APPLICATION FOR PERMISSION
UNDER SECTION 16 OF
THE TOWN PLANNING ORDINANCE
(CAP.131)

For Official Use Only 請勿填寫此欄	Application No. 申請編號	A/KC/489
	Date Received 收到日期	17 JAN 2022

Application No. 申請編號	(For Official Use Only) (請勿填寫此欄)		
Location/address 位置／地址	葵涌九華徑測量約份第 4 約多個地段及毗連政府土地 Various Lots in S.D.4 and Adjoining Government Land, Kau Wa Keng, Kwai Chung, New Territories		
Site area 地盤面積	48,313.167 sq. m 平方米 <input checked="" type="checkbox"/> About 約 (includes Government land of 包括政府土地 22,238.303 sq. m 平方米 <input checked="" type="checkbox"/> About 約)		
Plan 圖則	葵涌分區計劃大綱草圖編號 S/KC/29 Draft Kwai Chung Outline Zoning Plan No. S/KC/29		
Zoning 地帶	「綜合發展區」 “Comprehensive Development Area” (“CDA”)		
Applied use/ development 申請用途／發展	擬議綜合發展包括分層住宅及學校（幼稚園） Proposed Comprehensive Development including Flat and School (Kindergarten)

**Proposed Comprehensive Development including Flat and Community Facilities
in "Comprehensive Development Area" Zone at Various Lots in S.D.4
and Adjoining Government Land, Kau Wa Keng, Kwai Chung
(Planning Application No. A/KC/489)**

附圖(一)

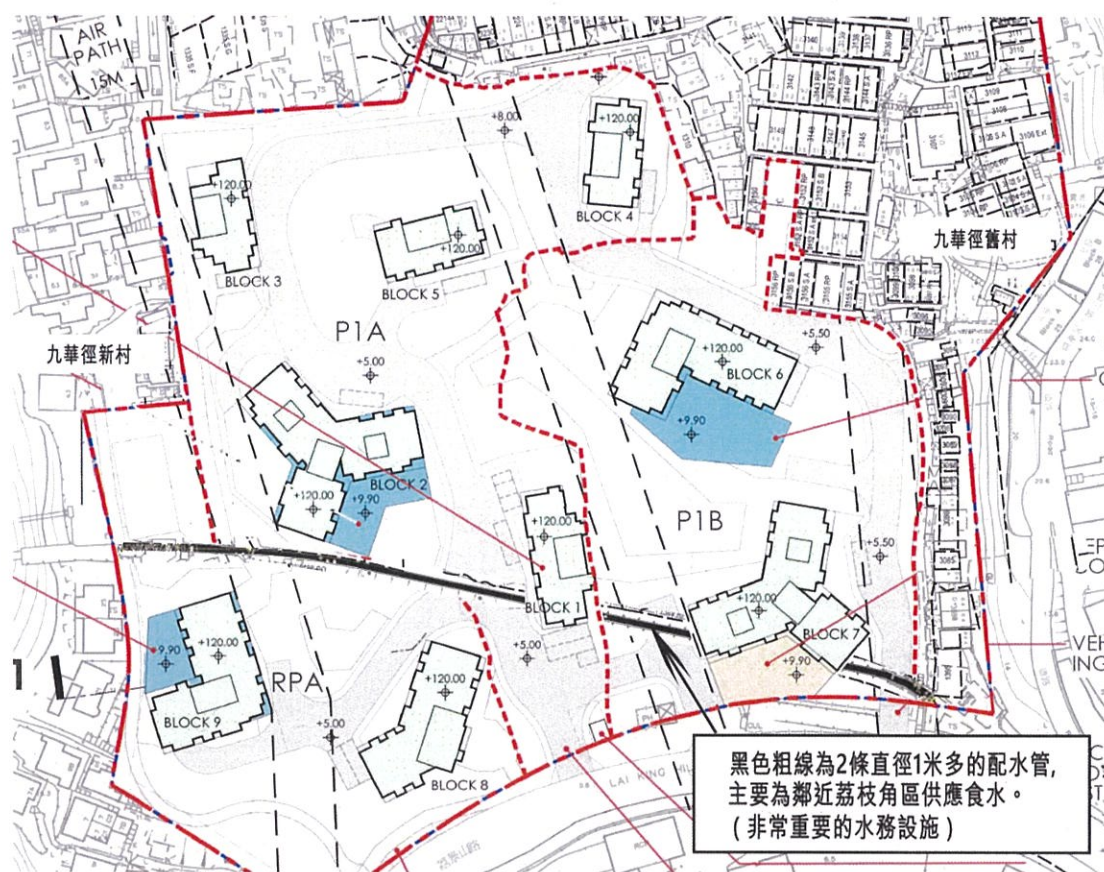
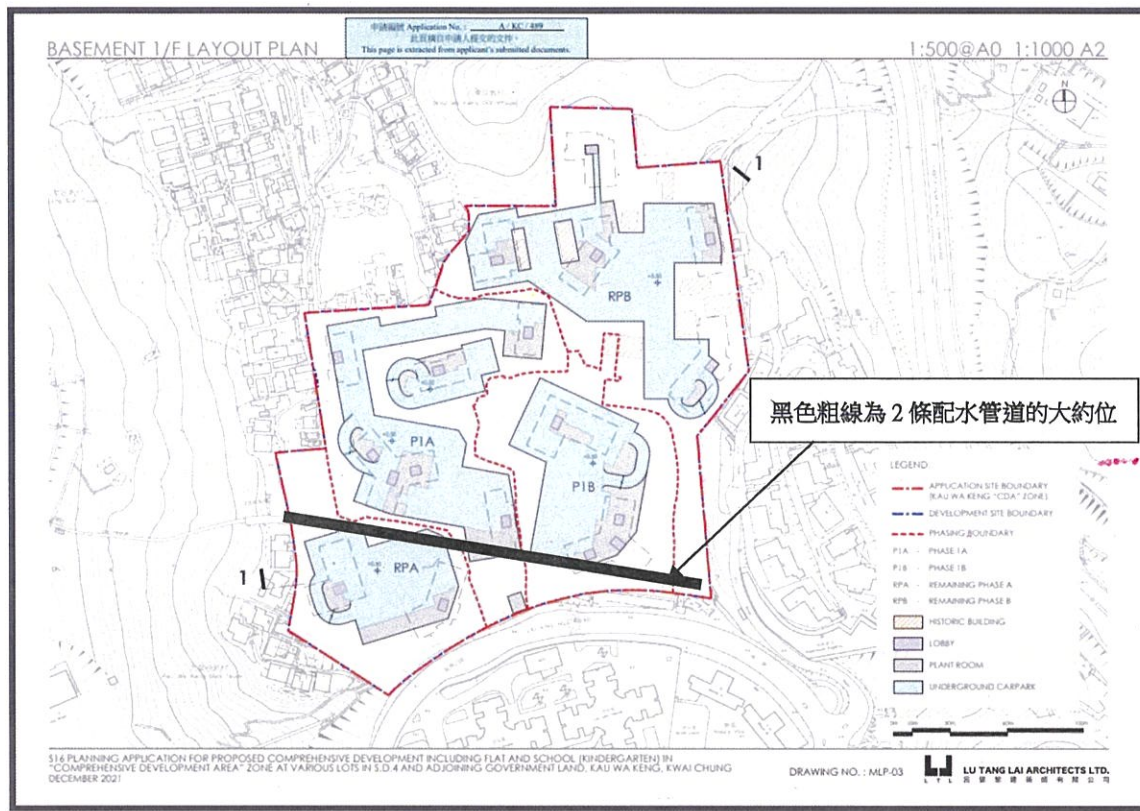
- 查九華徑山谷的中央有一非常重要的配水管道，由 2 條直徑一米多的大水管組成，主要將瑪嘉烈醫院/葵涌醫院旁邊水務署的荔枝角配水庫的食水輸送至整個荔枝角區域。因此，如依照發展商的規劃設計(興建大廈及地下停車場)，相信必定會損毀此配水管道。
- 從發展商的規劃設計圖，可得知擬建大廈第 1 座、第 2 座及第 7 座與擬建的馬路、花園等設施必定會直接損毀此配水管道(見附圖(一))，同時，擬建之地下停車場亦會損毀此配水管道(見附圖(二))。
- 於建築期間內，發展商如何保證此配水管道的安全？規劃發展完成後，此配水管道如何進行維護、保養及修理？

發展商至今仍未能對該配水管道問題提出任何解妥善的決方案！經仔細審視是次規劃發展建議，要解決此配水管道問題，相信發展商須要重新規劃及更改設計。由於配水管道是葵青及本區的居民食水供應命脈，所以於水管問題未得到妥善解決前，此規劃申請是否應予以否決。希貴會委員及水務署官員垂注。謝謝！
